**ADDENDUM TO THE HARRY RENFREE FIELD RENOVATIONS PROJECT AT DEL PASO  
REGIONAL PARK (SCH: #2023090065)**

The City of Sacramento Community Development Department, California, a municipal corporation, does hereby prepare, declare, and publish this Addendum to the Project's IS/MND to modify the Project description to include the installation of approximately 444 feet of two new electrical conduit lines.

**File Number/Project Name:** Harry Renfree Field Renovations Project at Del Paso Regional Park (Project No. L19300002; SCH: #2023090065)

**Figure 3**  
**Project Features**

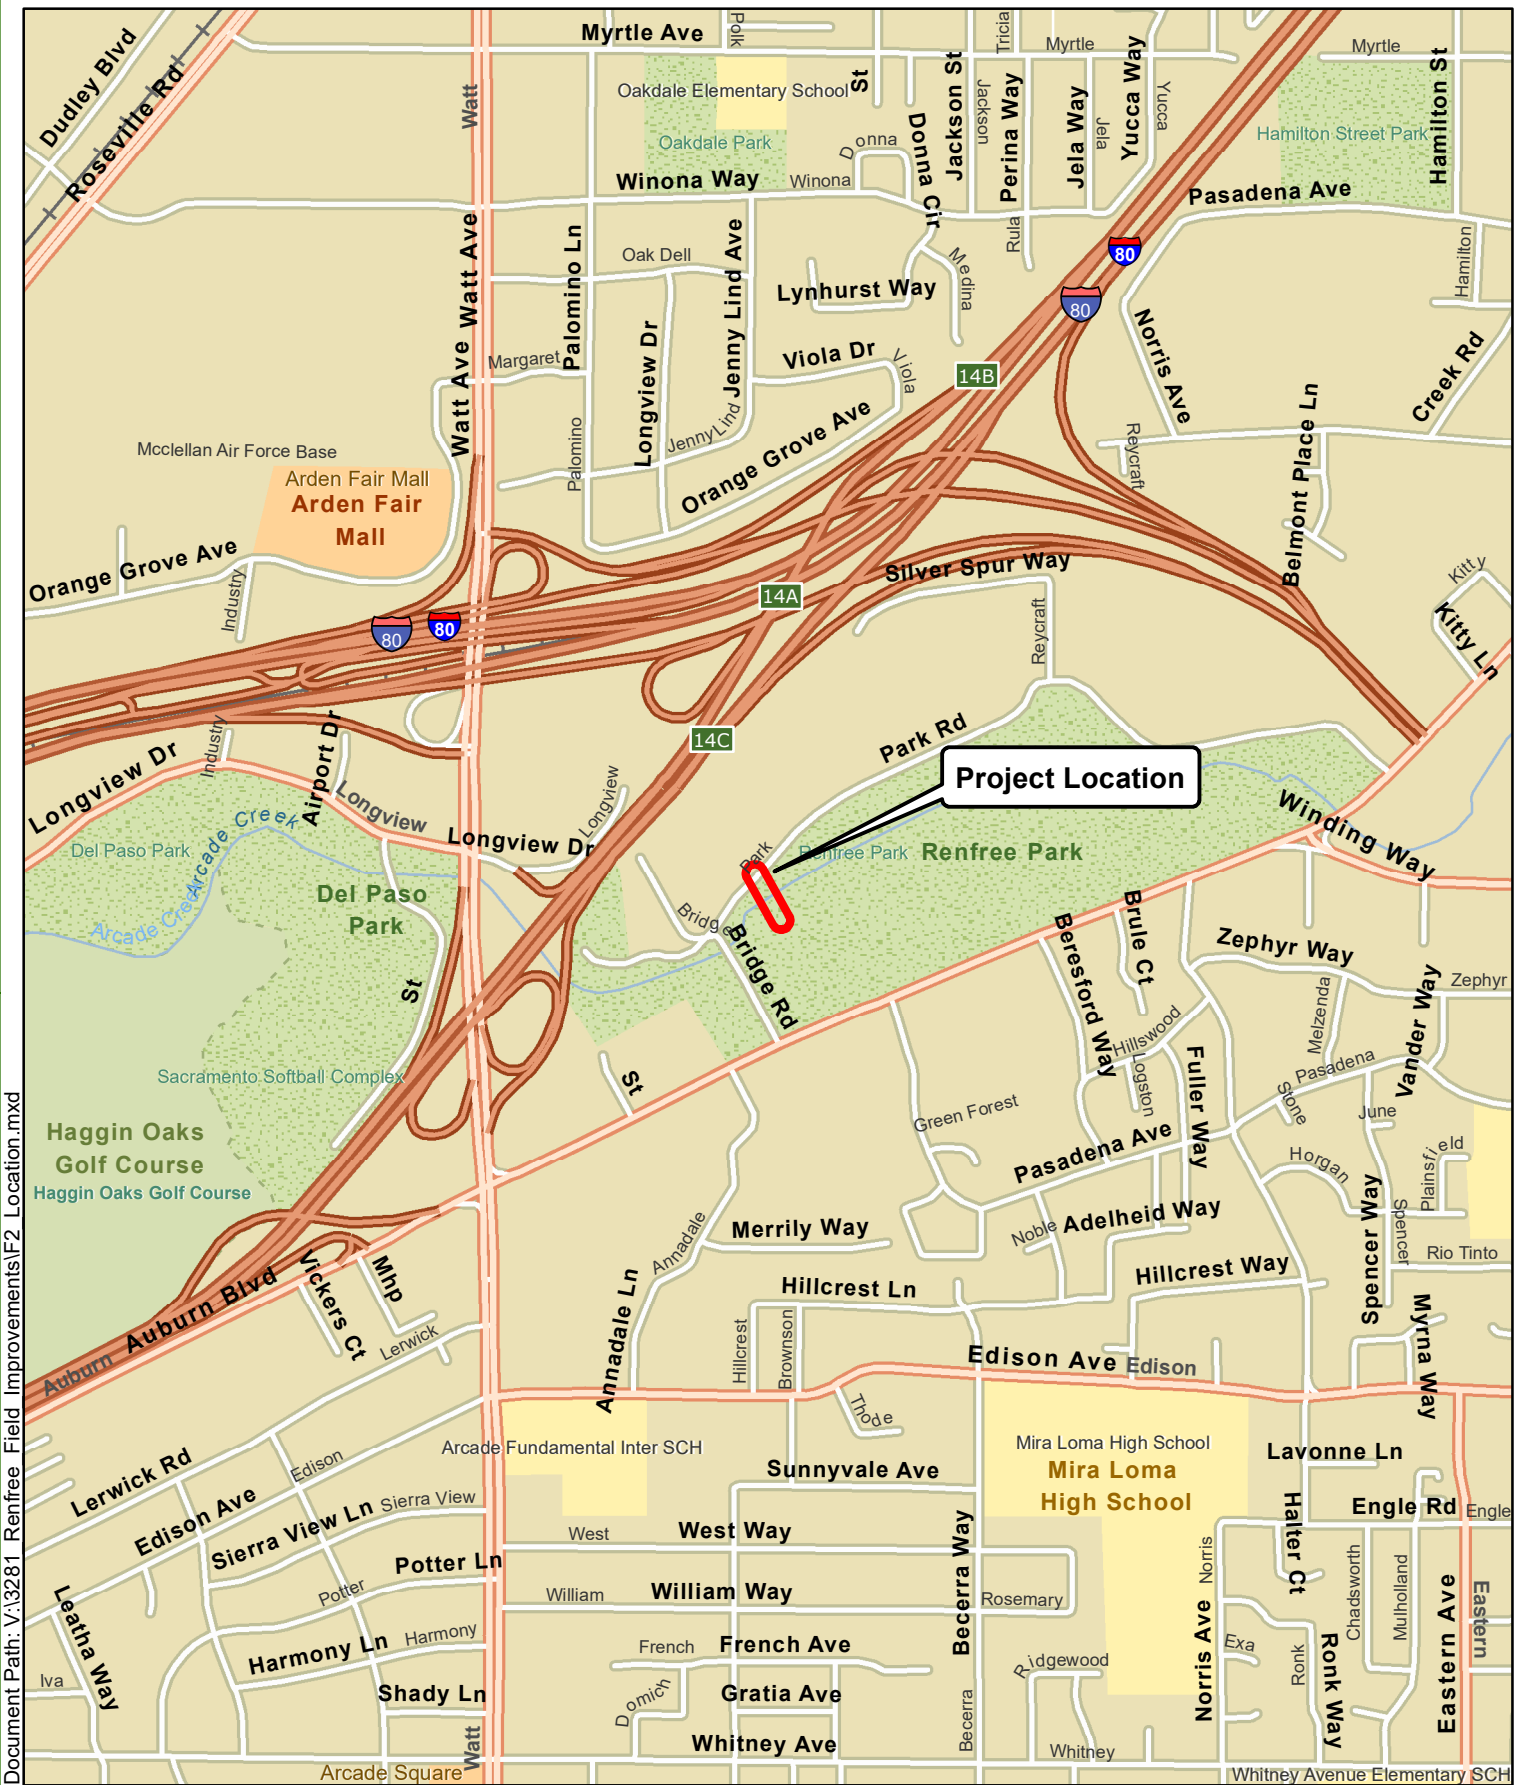
**Project Description:** The current proposal requests a minor modification to the Project description from the Harry Renfree Field Renovations Project at Del Paso Regional Park IS/MND. This modification involves the installation of two electrical conduit lines, each approximately 222 feet long. These new conduits will run from an existing SMUD utility pole located north of the field on Park Road, cross under Arcade Creek, and connect to the existing SMUD utility box at Renfree Field to provide electricity to the new facilities (Attachment A. Figure 3). The new electrical conduits will be installed via horizontal directional drilling (HDD) to avoid impacts to sensitive habitats, including Arcade Creek and its riparian corridor.

*Changes to the original Project described in the certified IS/MND include the addition of approximately 444 feet of underground electrical conduit. These conduits will be installed starting at an existing SMUD utility pole located north of the existing field along Park Road, cross under Arcade Creek, and connect to the existing SMUD utility box at Renfree Field. The 2024 IS/MND originally anticipated connecting the proposed Project facilities to electrical lines located along Auburn Boulevard near the children's playground. However, since the IS/MND's approval, the City determined that new conduits are necessary to provide electricity to the new facilities. To minimize environmental impacts, the City proposes to install the conduits using HDD, which will avoid disturbance to Arcade Creek and its associated riparian corridor. Access pits for the drilling process will be placed outside of these sensitive areas, ensuring there are no indirect or direct impacts to the jurisdictional water, Arcade Creek, or its associated riparian habitat. No surface disturbance will occur between the access pits and backfill material will not be required. Construction impacts from the HDD process will be short in duration and abide by all relevant City of Sacramento Ordinances, as well as the 2040 General Plan.*
